Access Compliance Report

Public Rights-of-Way

Intersection ID: N/A	Main Street: SHARON_LAKES_RD	Cross Street: WATERFORD_LAKES_DR	Location: SW
ADA ID: 9F248F7636BF	Ramp Type: PerpDiag	Initial Pass/Fail: Fail	Overall Compliance: No
		Severity Score: 12.5

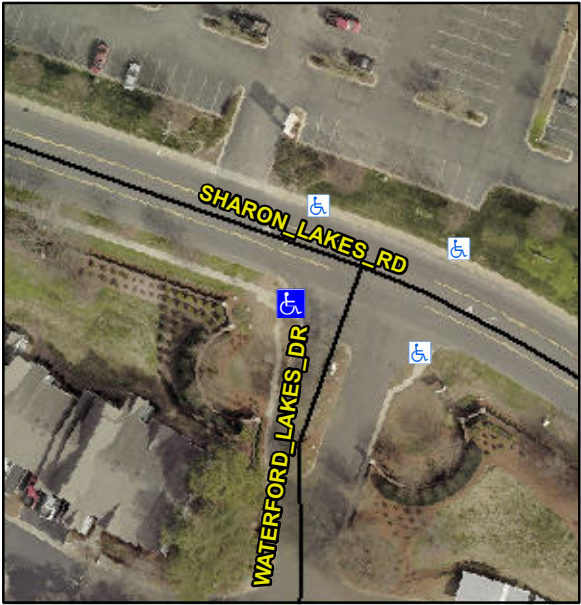
Codes/Mitigation Info/Possible Solution			Field Measurements/Component Compliance		
	Possible Solutions:		Compliance	Description	Data
	Remove & Replace Curb Ramp With Two New Directional Ramps or Equivalent.		N/A	Ramp Length (in)	68.0
			Yes	Ramp Width (in)	48.0
			N/A	Flare Type LT	N/A
			N/A	Flare Slope LT (%)	N/A
			N/A	Flare Traversable LT?	N/A
			N/A	Landing Length (in)	N/A
			N/A	Landing Width (in)	N/A
			N/A	Landing Slope (%)	N/A
			N/A	Landing X Slope (%)	N/A
<p>Surveyor Notes:</p> <p>N/A</p> <p>PROW/ADA:</p> <p>R304.5.3</p>			N/A	Flare Type RT	N/A
			N/A	Flare Slope RT (%)	N/A
			N/A	Flare Traversable RT?	N/A
			N/A	DWS Provided?	N/A
			N/A	DWS Contrast?	N/A
			N/A	DWS Length (in)	N/A
			N/A	DWS Full Width?	N/A
			N/A	DWS Offset (in)	N/A
			N/A	Gutter Ponding?	N/A
			N/A	Gutter Lip Ht (in)	N/A
			N/A	Painted X Walk1?	No
				X Walk 1 Direction	To SE
			N/A	X Walk 1 Width (in)	N/A
				X Walk 1 Slope (%)	1.9

X Walk 1 X Slope (%)	2.3
			N/A	Ramp inside XWalk1?	N/A
				Road Slope (%)	2.6
				Road X Slope (%)	2.2
			N/A	Any Obstructions?	N/A
				Obstruction Type	
Total Cost: \$ 3200.00			N/A		N/A
			Yes	Surface Condition? (G/P)	Good
